CABINET MEMBER FOR ENVIRONMENT – 19 NOVEMBER 2020

DIDCOT: BRASENOSE ROAD & SLADE ROAD AREA - PROPOSED TRAFFIC CALMING MEASURES & 20MPH SPEED LIMIT

Report by the Interim Director of Community Operations

Project title
PROPOSED 20 MPH SPEED LIMIT

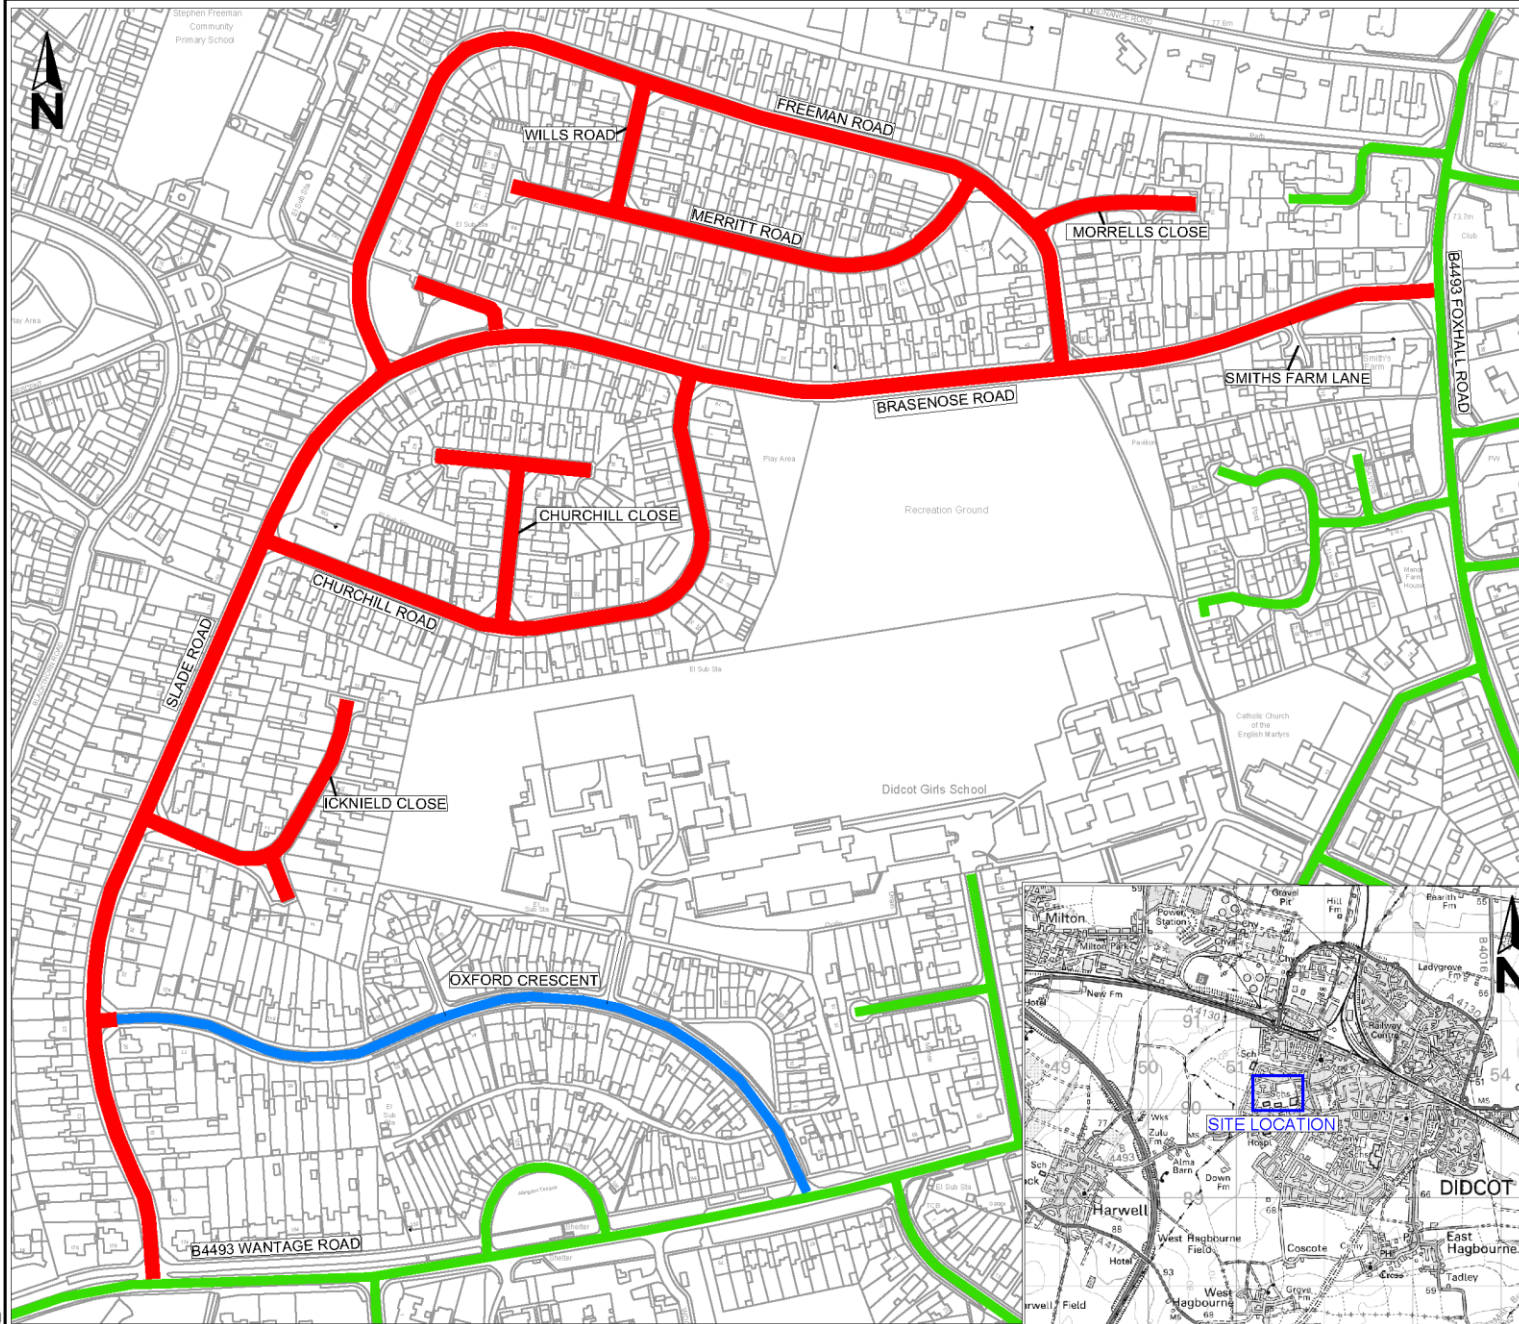
8. Thames Valley Police objected to the proposals. They do not consider that the zone as proposed will be self-enforcing on the roads other than Brasenose Road and Slade Road where traffic calming is proposed in accordance with Department for Transport advice on 20mph speed limits and zones and also taking account of the lack of speed surveys to inform their comments on this proposal.

10. Didcot Town Council support for the proposals
11. Cycling UK Oxfordshire support the speed limit but expressed concerns over the detailing of the proposed traffic calming measures in respect of the effectiveness of speed cushions and the safety and ease of passage for cyclists including three-wheel pedal cycles and requested consideration of cycle bypasses in accordance with current national advice on the provision for cyclists.

13. Objections and concerns in respect of the proposed traffic calming measures were received from thirty-one members of the public, all residents of properties adjacent to the proposals. One of the main grounds for specific objection was the perceived difficulty the proposed cushions might cause for vehicle turning to and from driveways close to the cushions and the consequent accident risk; more general grounds for the objections included concerns over the need for and cost of the proposals, with some respondents noting that on-street parking in the area was effective in helping to reduce speeds; other issues raised included increased noise and vibration as vehicles traverse the speed cushions, and over increased engine emissions

17. Thirteen objections or concerns over the proposed 20mph speed limit were received from members of the public. Specific reasons cited included the actual need for the limit, with one suggestion being made that it was only required at school journey times

9. Noting the police response, the layout of the roads without proposed traffic calming measures are considered to be suitable for a 20mph zone taking account of their alignment and length.

12. Noting the above concerns, the type of calming measures proposed here have been very widely used in Oxfordshire, including on roads with high cycle flows, and have been found to be effective and not to present a difficulty or hazard to cyclists. The scope to adjust the lateral positioning of the cushions will be investigated to provide space as close to the recommended 1.5m spacing as possible.

14. Noting the above, the proposals comprise speed cushions, which will allow vehicles to travel along the road within the speed limit without significantly adjusting their speeds, resulting, therefore, in no increase in vehicle emissions and – from experience of similar schemes elsewhere - minimal if any change in noise.

16. In respect of the expressed over the difficulties the proposed cushions might cause for vehicle turning to and from driveways close to the cushions, adjustments have been made where considered appropriate to the placement of the cushions to address specific concerns raised, while also noting that speed cushions have been widely used in comparable residential roads with many vehicle accesses, with cushions sited very close to driveways, but with no reported problems.

18. Noting the above, 20mph speed limits are commended in national guidance on setting local speed limits as being appropriate in residential areas, as is the case here.
